## ASTORIA PARKS & RECREATION ADVISORY BOARD

# SHIVELY PARK AND MCCLURE PARK MASTER PLAN

Open House #1 Meeting Summary  
 April 11, 2017  
 Shively Hall

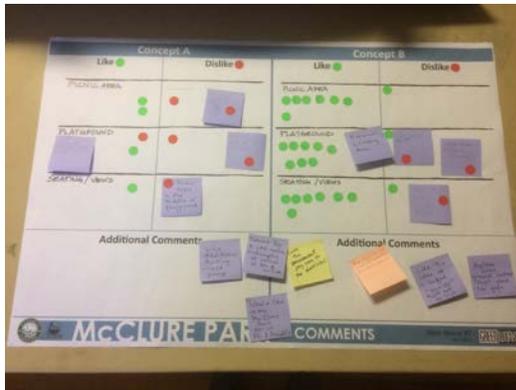
- There should be plenty of space or separation between the bottom of the slide and the play area for safety.

- Would the swing set be a two-seater or a four-seater?  
*Response: A four-seater is shown in Concept A. Concept B includes multiple swing types on separate support structures but all of that is flexible.*

- I don't see too many bright colors which is good but what materials are you considering for the play equipment? Would you use wood.  
*Response: We could use wood but we would not recommend it for this climate due to maintenance and longevity reasons. We would suggest steel and your color choices would be almost endless, including subdued or more natural colors.*

- Are you planning to raise the level of the grade of the picnic area? The side of the park has significantly subsided and will continue to do so if we don't shore it up.  
*Response: Our understanding is that the movement of the slope is occurring gradually and at a deep level. Stabilization would need to occur at a significant depth and would be very expensive so we are not suggesting that at this time although it could be done if the resources are available. Improving the drainage in the park will also help address that to some degree.*

- What kind of surface material are you suggesting in the play areas – wood chips or something else? The wood chips tend to get wet and need to be almost constantly replenished. And how deep would that need to be?  
*Response: We haven't suggested a specific material to this point. That is more of a design detail. However, you could use either wood chips, rubber/synthetic chips or a molded rubber surface. Recent studies have shown that the molded rubber surfaces can be more prone to causing injuries like sprains. The depth of the surface is usually 12-18 inches for chips and depends on the potential height someone could fall and the need to prevent head or neck injuries. The higher the height of the play equipment, the deeper the material.*

**Concept A**

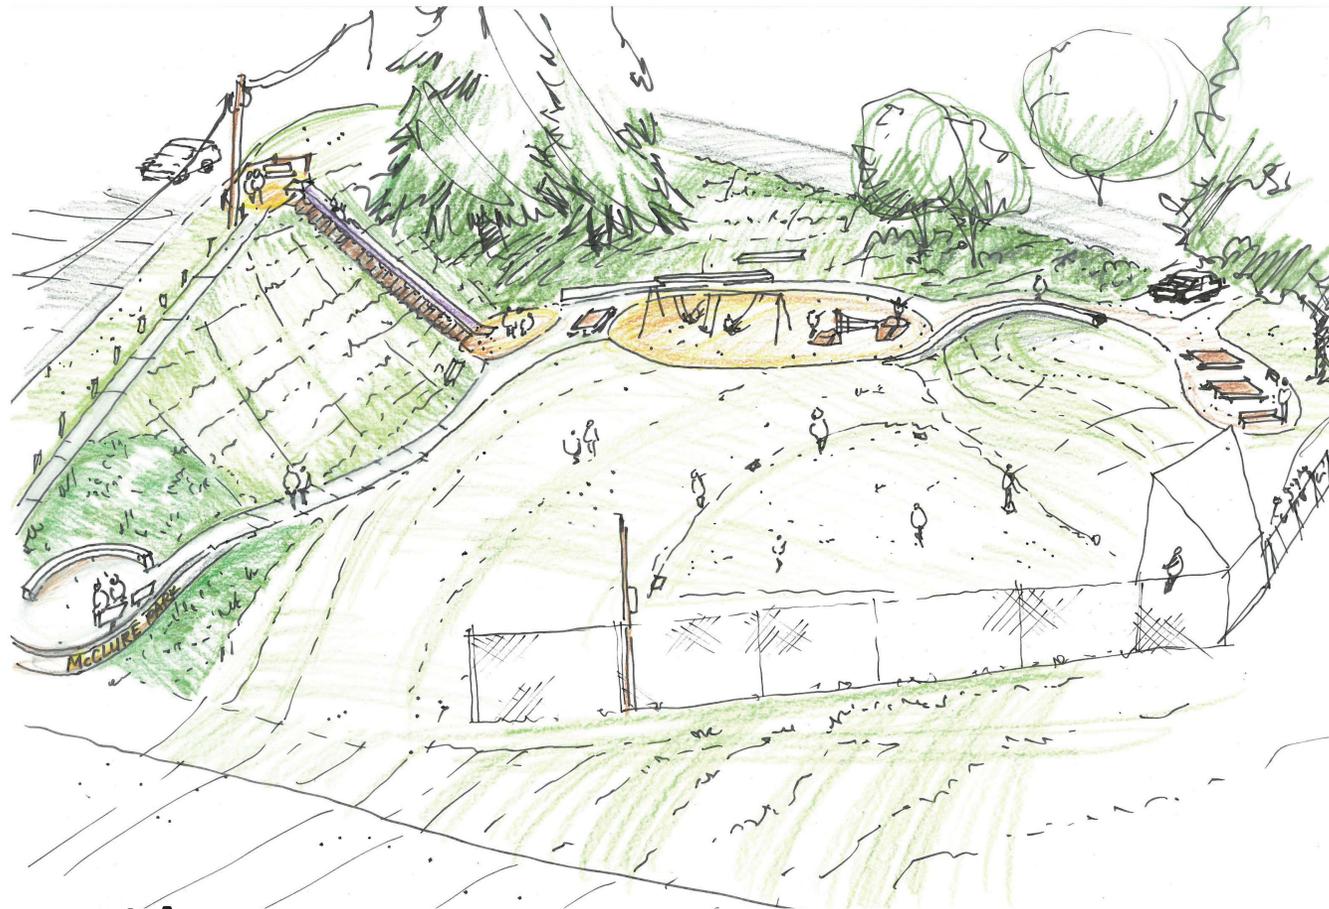
- Don't locate a picnic bench between the bottom of the slide and the playground.
- Not too cluttered with stuff (Concept A playground).
- No picnic table near the slide (Concept A picnic area). (2 comments)

- Climbing wall not necessary/don't like it (Concept A playground). (2 comments)
- Too much stuff (Concept B playground).
- Playground is too close to slide (Concept B playground).

**Concept B**

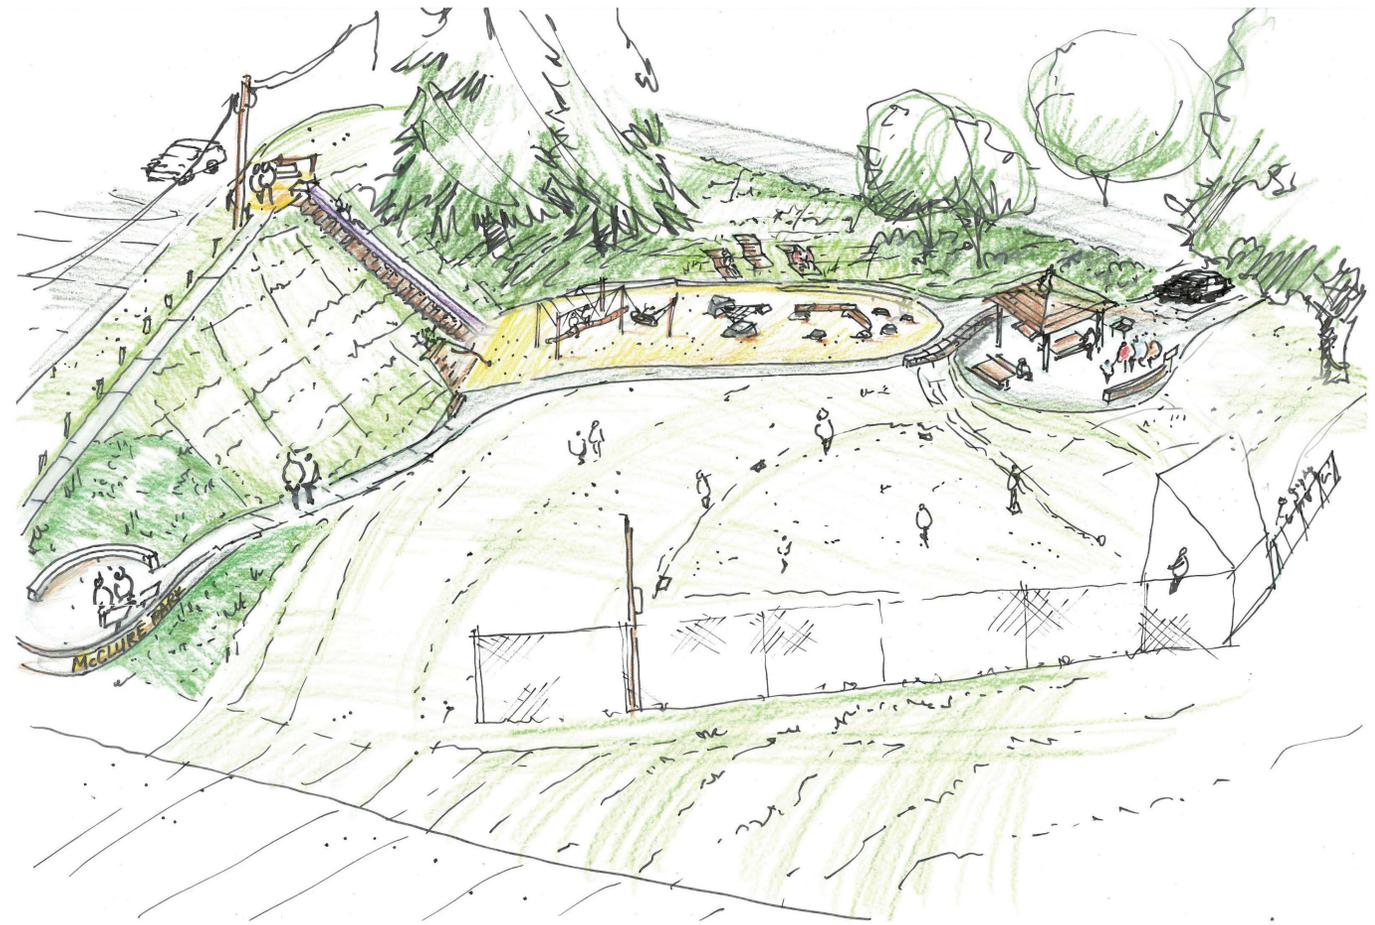
- Three (3) people noted a preference for Concept B for McClure Park. Additional comments included the following.
- Like sheltered picnic area, more play area.
- The shelter is a good concept. Separate bottom of slide from play area.
